PARTS & SERVICE NEWS

REF NO. AT04164

SUBJECT: MODIFICATION PROCEDURE FOR CLAMPING DRAIN TUBE OF MUFFLER (SAA6D114E-2)

APPLICATION: WA380-5 Wheel Loaders, S/N 60001 and up
WA400-5 Wheel Loaders, S/N 70001 and up

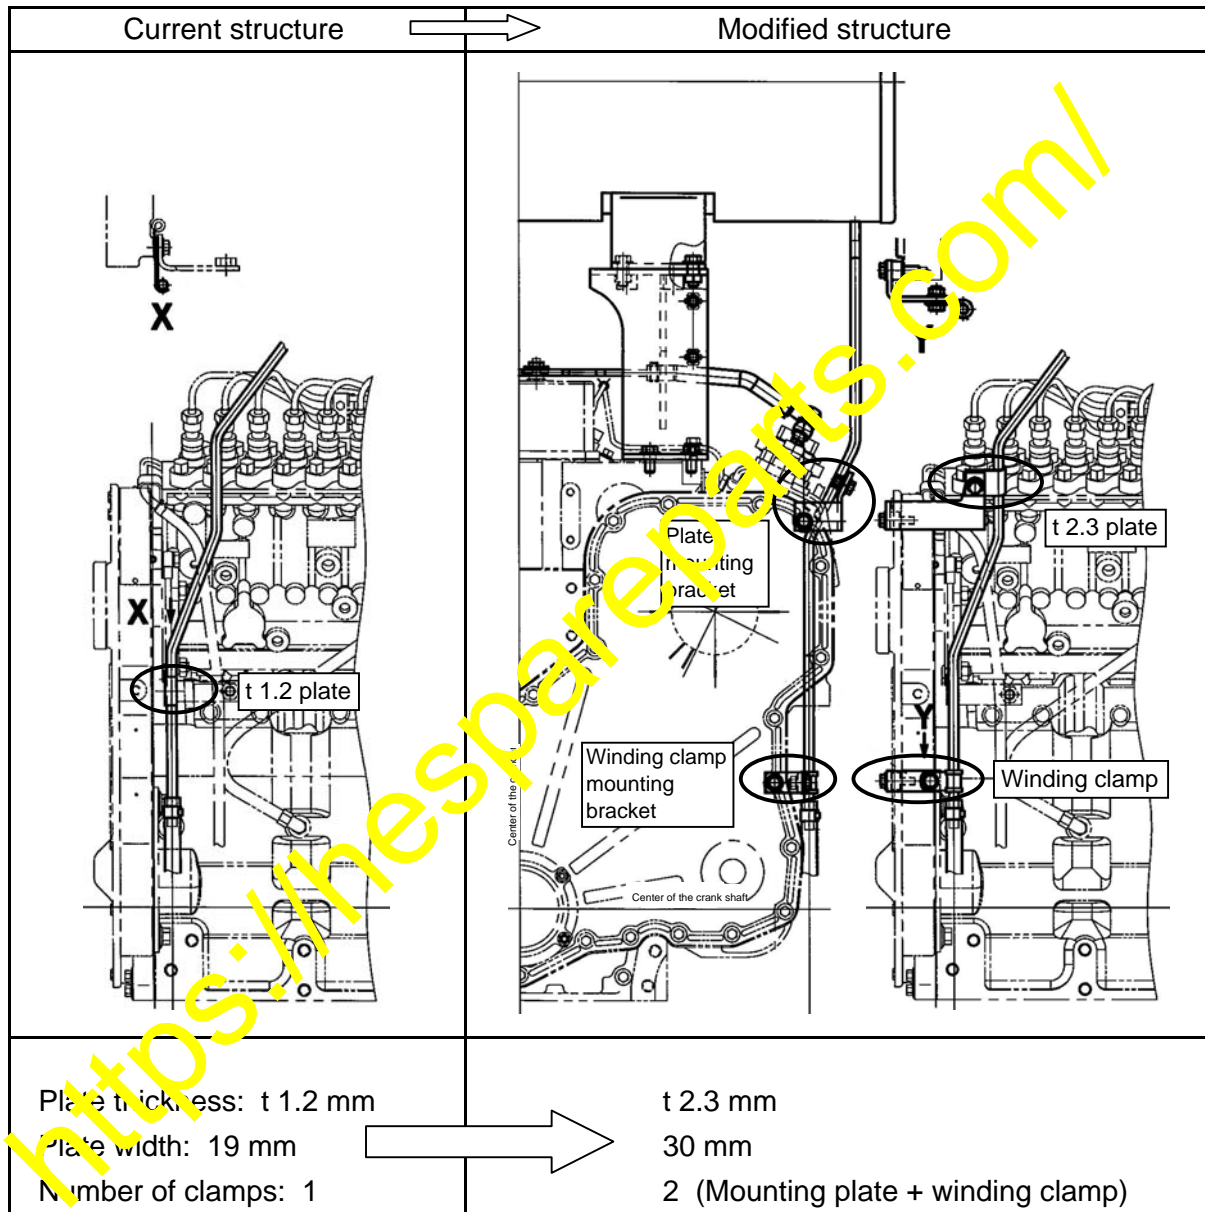
The mounting plate for the drain tube of the muffler for the SAA6D114E-2 engines installed on the wheel loaders may break. When the above drain tube mounting plate breaks, repair following the procedure as outlined in this **Parts & Service News**.

The fixing method for the drain tube of the muffler is to be changed as follows to increase the strength, thus preventing the plate from cracking.

- 1) The plate thickness and the plate width of the drain tube mounting plate are to be changed to increase the strength.
- 2) A winding clamp is to be added.

- 1) Remove the broken drain tube.
- 2) Remove the bolts for the front gear cover at the two places (marked ★) in the drawing shown below.
- 3) Temporarily tighten the mounting brackets 6743-11-5570 and 6743-11-5480 with the bolt (01435-00830) via the spacer (6691-41-8230).
At this time, apply liquid gasket to the range of 10 to 20 mm under head of the bolt.

- 4) Inserting the improved drain tube 6743-11-5361 into the muffler side tube, temporarily fasten it to the upper side bracket by use of the bolt (01435-00816) and nut (01584-00806) carefully not to apply a strong force to the tube.
Tighten the bracket side bolt and the tube side bolt. (Tightening torque: 2.8 - 3.5 Nm)

- 5) Temporarily fasten the clip (6151-53-8190) to the lower side bracket by use of the bolt (01435-00816) and nut (01584-00806) carefully not to apply a strong force to the tube.
Tighten the bracket side bolt and the tube side bolt. (Tightening torque: 2.8 - 3.5 Nm)

- 6) Reinstall the drain hose and clip to the original positions.
